BICYCLE AND PEDESTRIAN
ADVISORY COMMITTEE
JULY 08, 2021
5:30 PM
ATTEND VIRTUALLY

For Agenda Item 7.a.i.

30% Design Plan for Harrison Road Sidewalk and Lighting Project (Note: Design Plan Set next page)

Planning and Funding Subcommittee Design Review Comments for Discussion: Sky Tallman, AICP, Chair

CONSTRUCTION PLANS FOR HARRISON ROAD

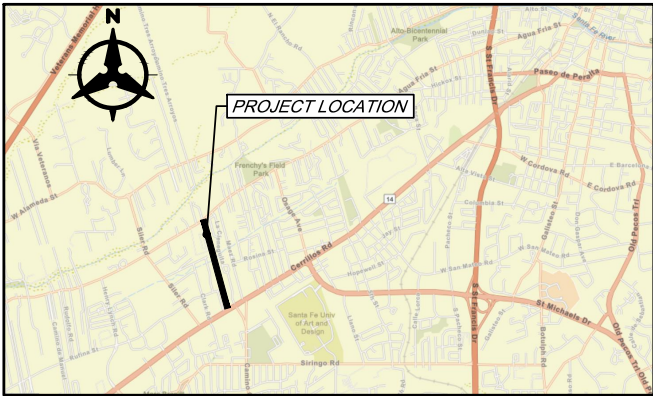
- Useful to plan for Acequia Trail connection for both bikes and peds where trail will cross.
- Intersection with Agua Fria – Curb radius should be narrowed. Is there a reason to design for large trucks?
